In this manuscript, a new analytical solution to the Boussinesq equation for variable widths and recharge rates is presented and analyzed.

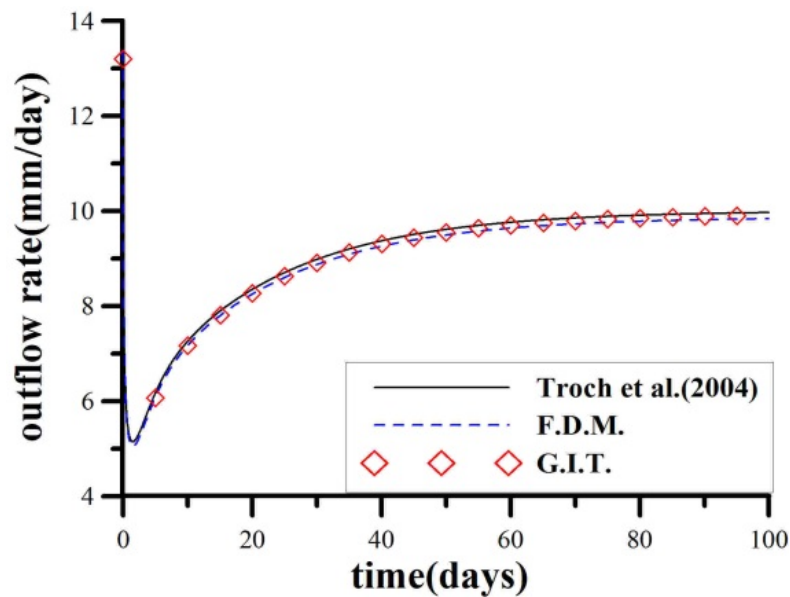
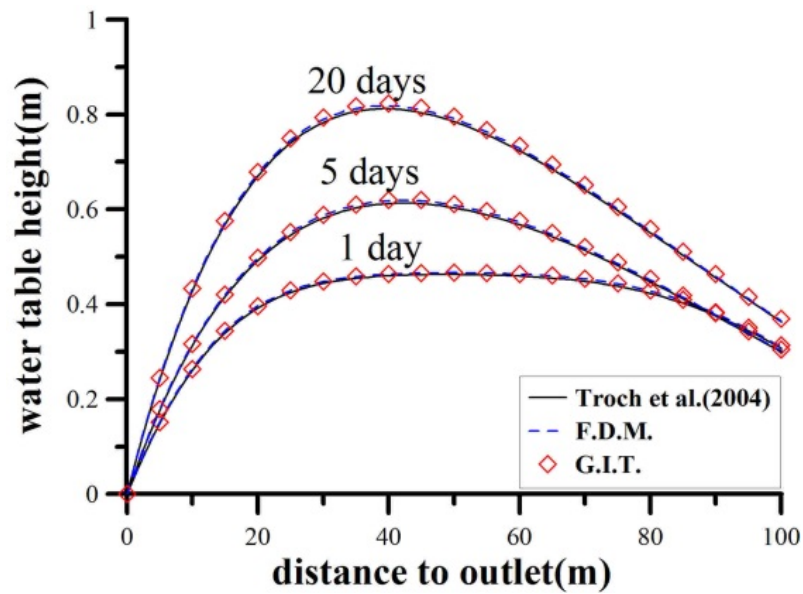
- My major concern is the statement on line 247: the analytical solution is supposed to be highly sensitive to the fitting parameter b . When comparing a numerical solution to an analytical solution, the results should ALWAYS be equal, regardless of the parameters that are used. The only exception is when oscillations are obtained, but then either the temporal or spatial discretization should be modified. Looking at figures 8 through 15, it is clear that the discrepancies are too large, and something must be wrong. I did not check the mathematical solution, but either there is an issue there, and/or there is something wrong in the coding, and/or the numerical solution has issues. This is something that must be corrected before the paper can be accepted.

Thank you very much for your comment. The reviewer said “When comparing a numerical solution to an analytical solution, the results should ALWAYS be equal, regardless of the parameters that are used.” I totally agree with this point when both solutions are derived from the same governing equations, initial/boundary conditions and input parameters. However, an analytical solution to a LINEARIZED governing equation is possibly not equal to a numerical solution to a NONLINEAR governing equation. This present analytical solution is obtained for a linearized equation, but the present numerical solution is for a nonlinear equation which was described on Line 177 (original version of MS) “a numerical model was developed to solve the original nonlinear equation, Eq. (4)”. Both solutions are to different governing equations, so

there are discrepancies in between. For the numerical solution by a finite difference method (F.D.M.) to the same LINEARIZED equation, the results are given below:

It shows that the numerical solutions are equal to the analytical solutions based on the same governing equations and same scenarios, thus justifying that the present analytical solutions are correct.
